Safety assessment of proposed improvements to RBMK nuclear power plants

*Report of the IAEA Extrabudgetary Programme
on the Safety of RBMK Nuclear Power Plants*

IAEA-TECDOC-694

The purpose of this report is to summarize the findings and recommendations of a Consultants Meeting convened by the IAEA in Vienna (27 October - 5 November 1992) to review new design features and modifications proposed or already implemented for RBMK reactors. This information was provided in four technical areas, namely: Core Monitoring and Control, Pressure Boundary Integrity, Accident Mitigation and Electric Power Supply.

FIG. 4. Fuel channel.

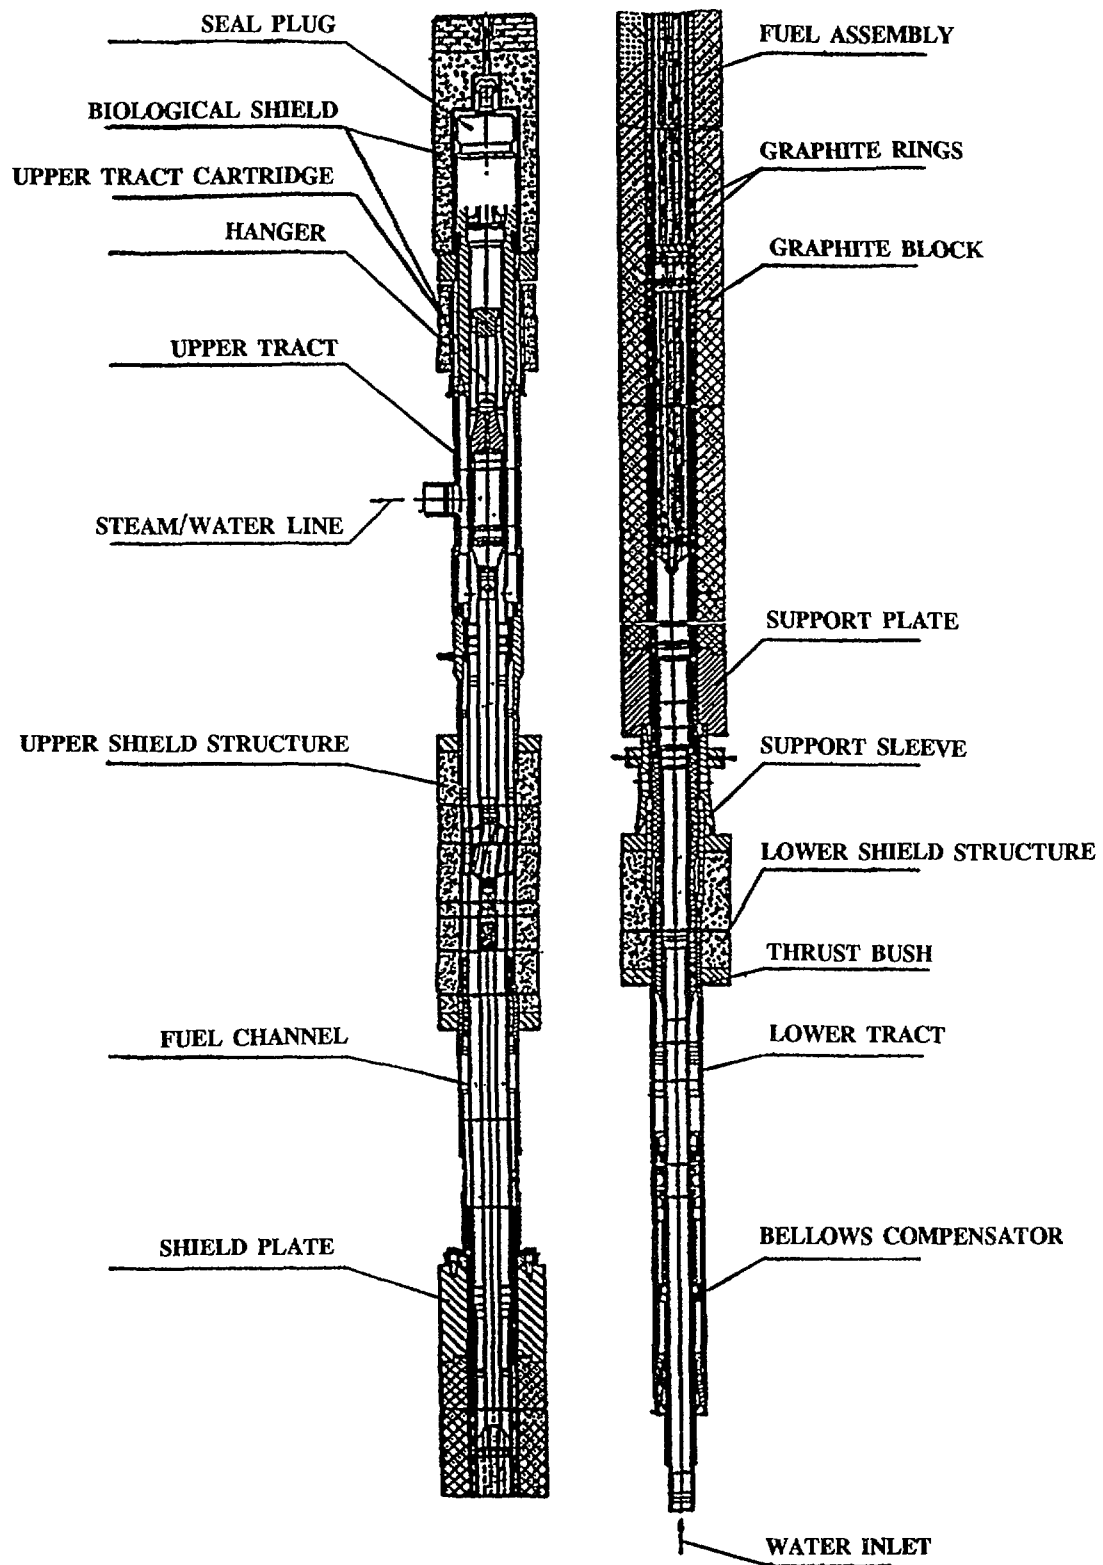
RBMK specialists described fuel channel design and continuing efforts to monitor the integrity of channels. Some 1600 of the total of 2000 channels are fuelled, with the remaining channels used for control rods, cooling graphite and other purposes. The fuel channel schematic drawing is given in Fig. 4.

Delayed hydride cracking (DHC) has been observed on the outside diameter of fuel channel tubes. Growth of DHC has been associated with high residual stresses, induced by the former technology of straightening tubes. The technology used at present has overcome this problem (due to the resulting lower residual stresses).

Numerical models of irradiation creep have predicted diametrical growth and closure of the gap between the fuel channel tube and the graphite. These calculations have somewhat under predicted the rate of gap closure observed in service, owing to the insufficiency of initial data.

- Volumetric 100% inspections of the fuel channels should be considered for implementation to analyse the development of sub-critical cracks. An eddy current type of device carried by the fuelling machine may enable this inspection to be done with each fuel change.

FIG. 8. Reactor coolant system nozzles: steam/water line - steam separator.

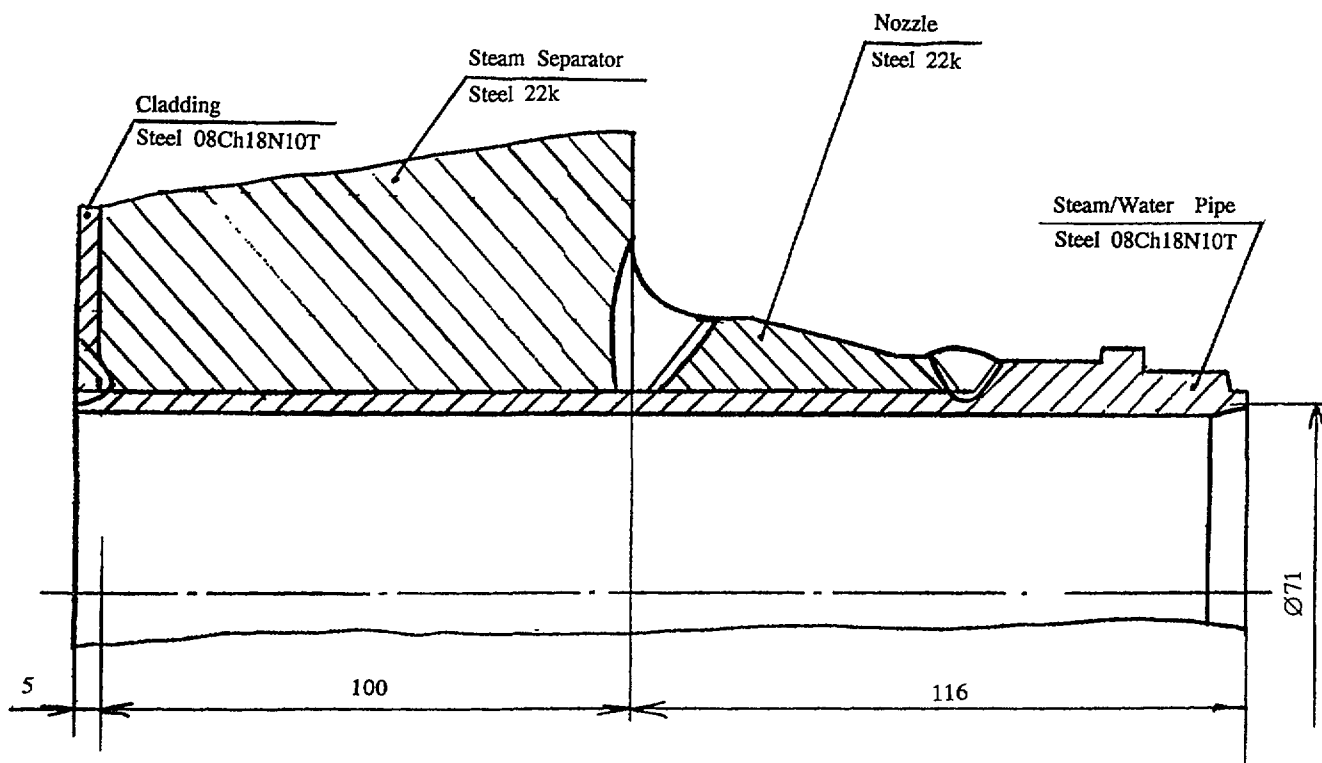
The steam separator has more than 400 nozzle connections. Some concern was expressed about the detail of the nozzle design; a sketch showing how these nozzles are manufactured in such large numbers on the stainless steel clad vessel is attached (Figs 8 - 11). The need for this detail was reinforced by the fact that on WWER reactors nozzle connections of stainless steel piping to clad carbon steel vessels have been of concern. The approach to this type of two material connection was to have the transition made at the factory, and to leave a simple stainless to stainless pipe weld for the field joint. To date there have been no cases of a connection failure.

The joint of steam/water pipes to the steam drum was discussed (see Fig. 8). This is a difficult metallurgical joint of carbon steel to stainless steel. Although the configuration of this nozzle joint is not covered by the ASME Pressure Vessel Design Code, it has performed well to date at all RBMK plants.

FIG. 17. Upgraded ECCS of RBMK 1000 (1st stage of construction).

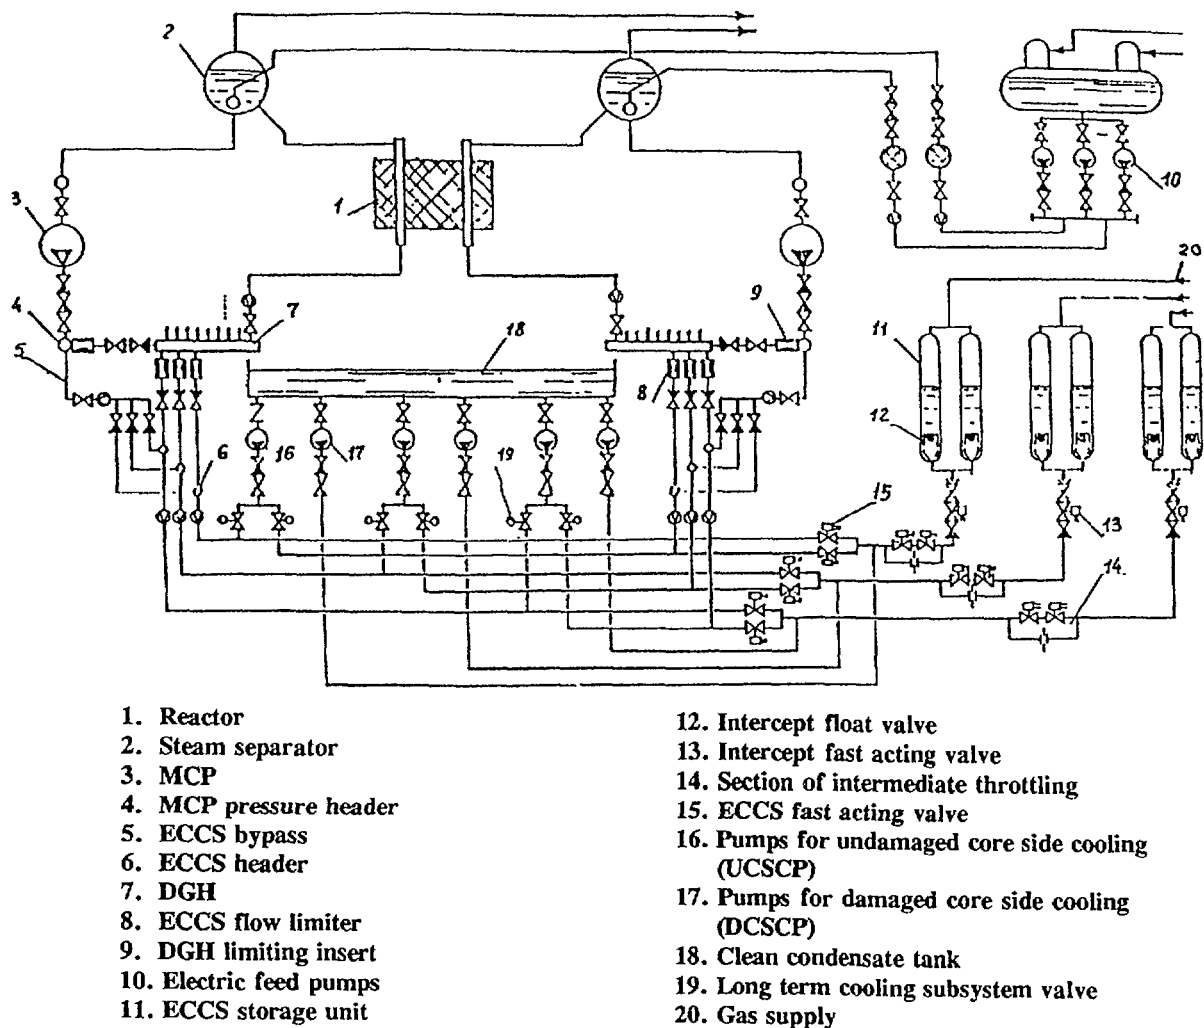
The fast acting valves (Figs 17 and 18) are electric motor operated gate valves. These valves are powered by a 'reliable power source' whose ultimate backup is battery power. These valves go from full close to full open in 10 seconds and are open sufficiently to allow injection of cooling water into the core within ~ 3 seconds.

These valves will normally operate with approximately 25 atm of pressure differential across them. They are tested and timed annually with this pressure differential. Note: it was pointed out by an RBMK specialist that these valves have also successfully operated with a much higher pressure differential.

There are three of these fast acting valves for each channel or division. One is located on the collection header downstream of the accumulators supplying that division; this valve is normally open and is designed to close when the accumulators are drained of water. The closure of this valve is based on the level in the accumulator (for Smolensk 3 it is based on level or time).

FIG. 18. Upgraded ECCS of RBMK 1000 (2nd stage of construction).

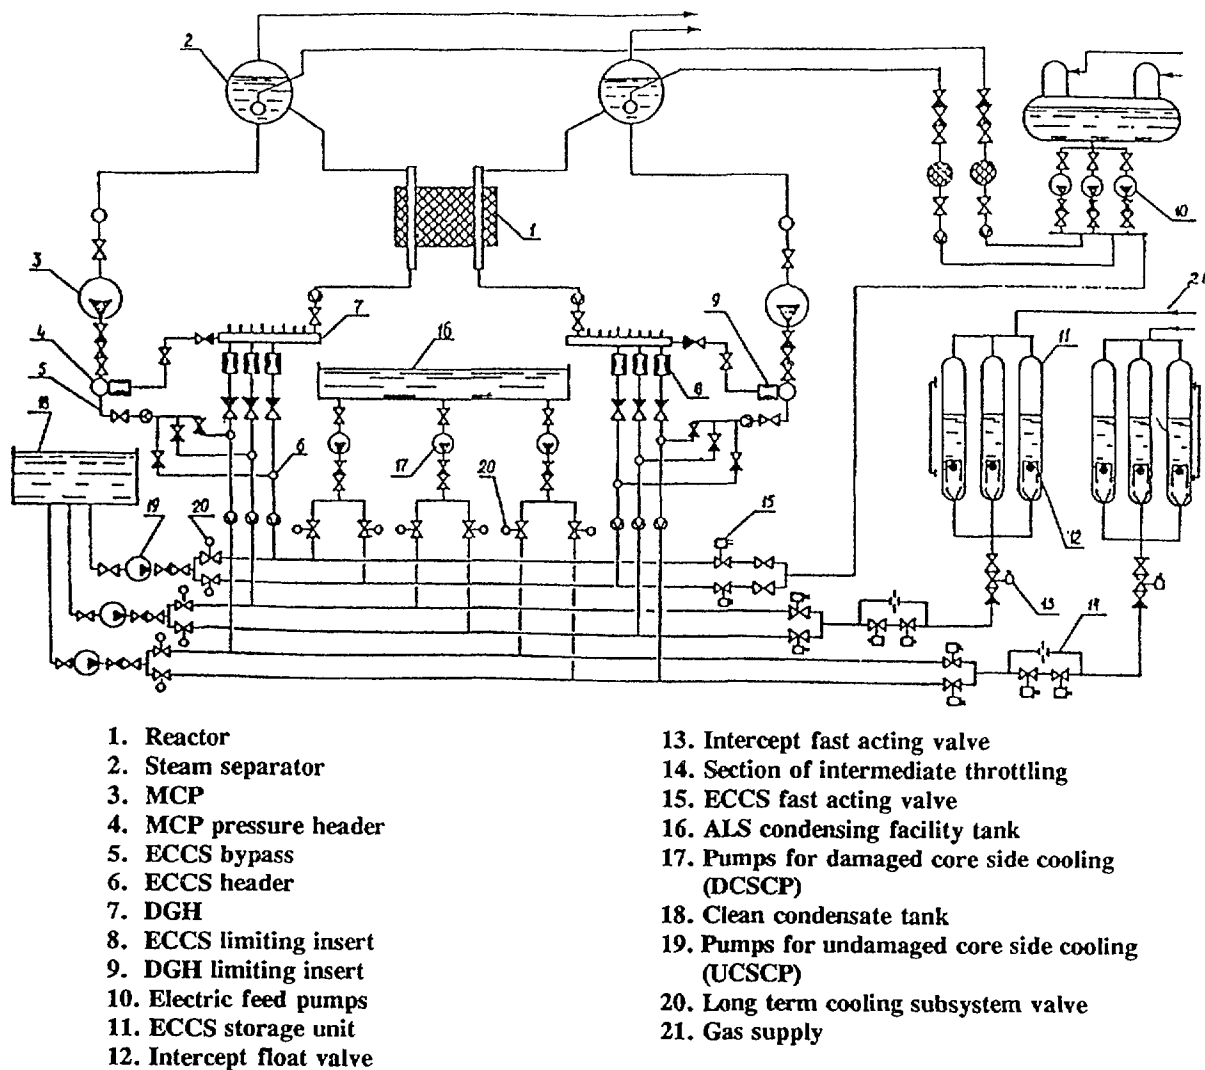
It was stated that experimental tests have shown that this float valve is not affected by the flow of vortices generated in the accumulator when the fast acting valve opens. It was pointed out that there had been a problem with this valve 'sinking' - but a level indication has been added and the level of the float valves is monitored.

It was also stated that there have been no problems in these tests with the closure of the float valve. However, it was pointed out that after it closes it sometimes took considerable effort to reopen it.

FIG. 20. Main interconnection scheme of Kursk NPP.

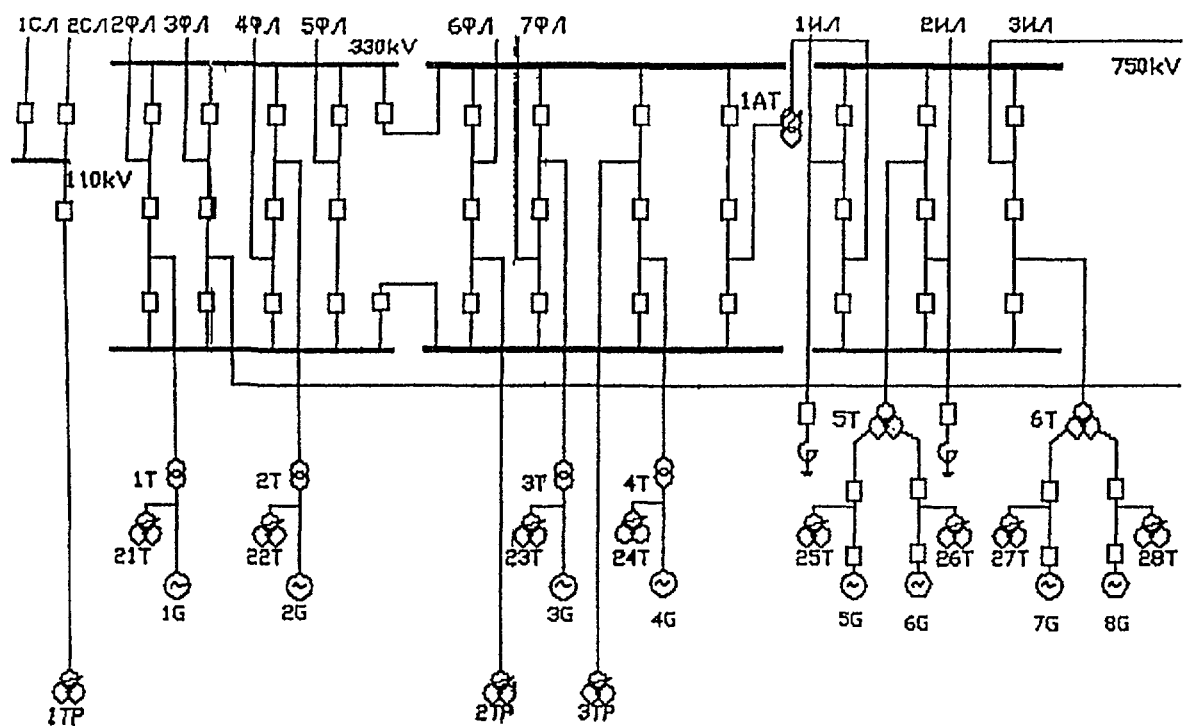
- All RBMKs are connected to the main grid via main transformers and standby transformers. Examination of the circuit diagram for the Kursk plant revealed a specific situation in which a single failure of one high voltage circuit breaker can lead to the loss of one turbine generator and its main grid connection at Unit 2 and one standby transformer of Units 3 and 4 at the same time (this, however, does not fail a safety function).

FIG. 22. Scheme of auxiliary power of Leningrad 1 (RBMK 1st generation).

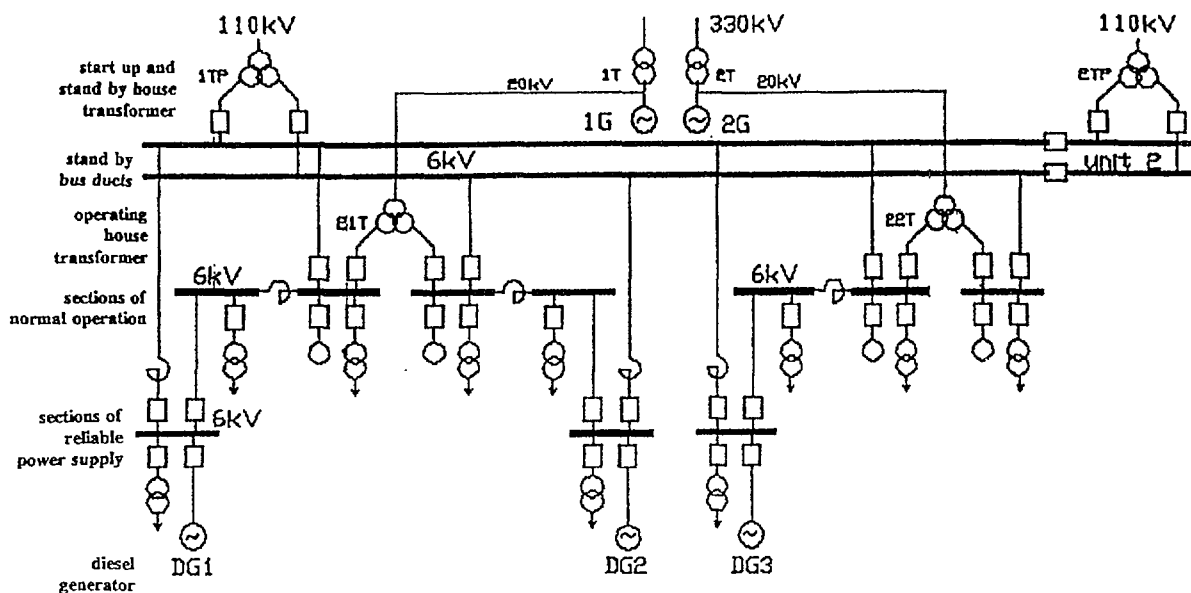
The general arrangement of safety and safety related channels was explained in detail for the 3rd generation of RBMKs. Three electrically, physically and mechanically separated trains are provided by the design for the safety systems. Each train has 50% of capacity. Additionally there are two safety related channels with 100% capacity each. The two safety related channels are independent from each other. There are a total of 5 diesel generators installed in the 3rd generation

of RBMKs, three of them are devoted to safety and two of them to the safety related channels. Within the 1st and 2nd generation of RBMKs three diesel generators serve safety and safety related functions at the same time. The philosophy of the design seems to meet the single failure criterion.

- A backfitting program is planned for the first generation of RBMKs. A new building, containing three new diesel generators and their associated support systems to supply the safety buses will be built. The existing three diesel generators are intended to supply normal and safety related systems only.

FIG. 25. Scheme of the reliable power supply train of Leningrad 1 (RBMK 1st generation).

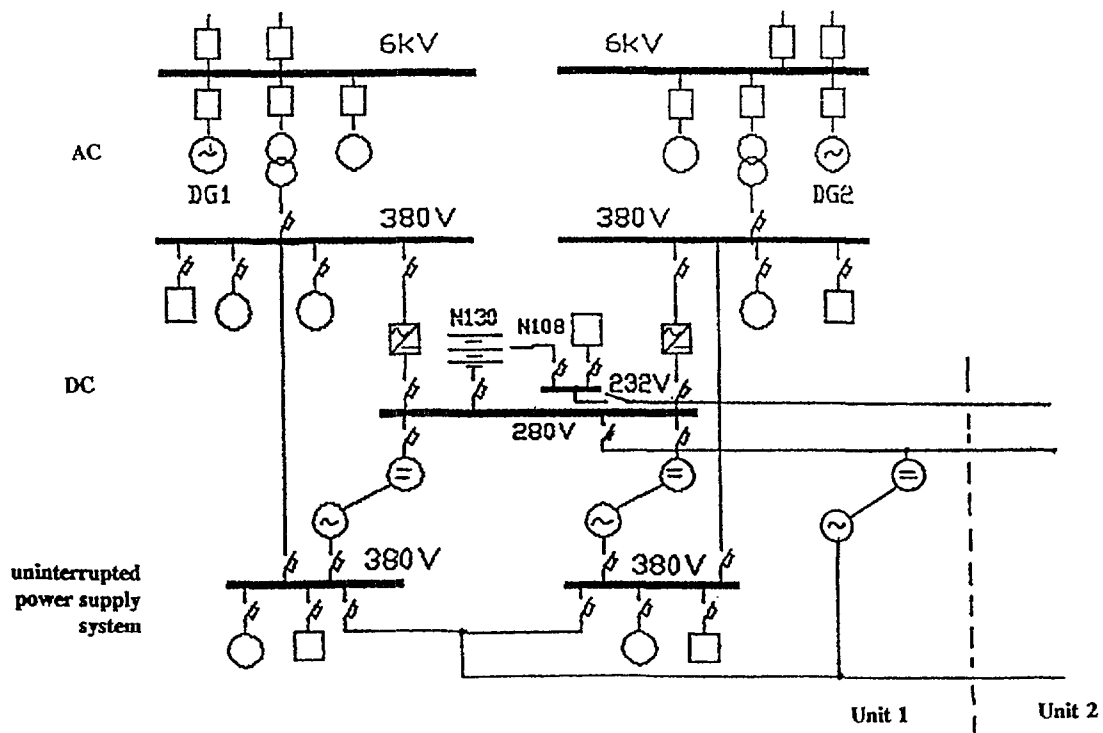
In the first generation RBMK, the DC supply is from a single battery and from a single sectionalized bus. This sectionalized bus supplies all three safety channels. A single failure can disable all safety circuits. In this case there is a possibility to recover DC supply by manual connection of batteries of the other unit. This will, however, take certain time. A change should be planned on high priority to install three DC buses and three batteries. These could be supplied from the three existing alternating current buses. The change should be co-ordinated with the larger backfit plan for new diesel generators and power circuits.
